# Access Compliance Report

## Public Rights-of-Way

Intersection ID: 10015703	Main Street: EASTWAY_DR	Cross Street: EASTWAY_PARK	Location: NE
ADA ID: B3B19236D5FF	Ramp Type: Perp	Initial Pass/Fail: Fail	Overall Compliance: No
			Severity Score: 25

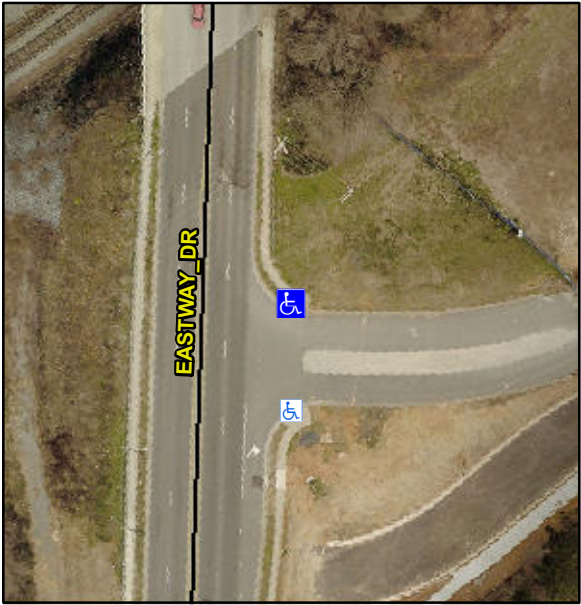
Codes/Mitigation Info/Possible Solution			Field Measurements/Component Compliance		
	Possible Solutions:		<b>Compliance</b>	<b>Description</b>	<b>Data</b>
	<b>Remove &amp; Replace Entire Ramp.</b>		<b>No</b>	Ramp Length (in)	<b>109.0</b>
			<b>Yes</b>	Ramp Width (in)	<b>48.0</b>
			<b>N/A</b>	Flare Type LT	<b>N/A</b>
			<b>N/A</b>	Flare Slope LT (%)	<b>N/A</b>
			<b>N/A</b>	Flare Traversable LT?	<b>N/A</b>
			<b>N/A</b>	Landing Length (in)	<b>N/A</b>
			<b>N/A</b>	Landing Width (in)	<b>N/A</b>
			<b>N/A</b>	Landing Slope (%)	<b>N/A</b>
			<b>N/A</b>	Landing X Slope (%)	<b>N/A</b>
<p>Surveyor Notes:</p> <p><b>N/A</b></p> <p>PROW/ADA:</p> <p><b>Not Found, R304.2.2, R304.5.3</b></p>			<b>N/A</b>	Flare Type RT	<b>N/A</b>
			<b>N/A</b>	Flare Slope RT (%)	<b>N/A</b>
			<b>N/A</b>	Flare Traversable RT?	<b>N/A</b>
			<b>N/A</b>	DWS Provided?	<b>N/A</b>
			<b>N/A</b>	DWS Contrast?	<b>N/A</b>
			<b>N/A</b>	DWS Length (in)	<b>N/A</b>

<b>N/A</b>	DWS Full Width?	<b>N/A</b>
			<b>N/A</b>	DWS Offset (in)	<b>N/A</b>
			<b>N/A</b>	Shared Landing?	<b>N/A</b>
			<b>N/A</b>	Gutter Ponding?	<b>N/A</b>
			<b>N/A</b>	Gutter Lip Ht (in)	<b>N/A</b>
			<b>N/A</b>	Painted X Walk1?	<b>No</b>
				X Walk 1 Direction	<b>To SW</b>
			<b>N/A</b>	X Walk 1 Width (in)	<b>N/A</b>
				X Walk 1 Slope (%)	<b>1.4</b>
				X Walk 1 X Slope (%)	<b>4.6</b>
			<b>N/A</b>	Ramp inside XWalk1?	<b>N/A</b>
			<b>N/A</b>	Ramp inside XWalk2?	<b>N/A</b>
			<b>N/A</b>	Road Slope (%)	<b>N/A</b>
			<b>N/A</b>	Road X Slope (%)	<b>N/A</b>
			<b>N/A</b>	Clear Space?	<b>N/A</b>
			<b>N/A</b>	Clear Space to XWalk (in)	<b>N/A</b>
			<b>N/A</b>	Storm Grate/Utility Hazard?	<b>N/A</b>
				Storm Grate/Utility Type	
			<b>N/A</b>		<b>N/A</b>
			<b>Yes</b>	Surface Condition? (G/P)	<b>Good</b>
Total Cost:		\$ 1850.00
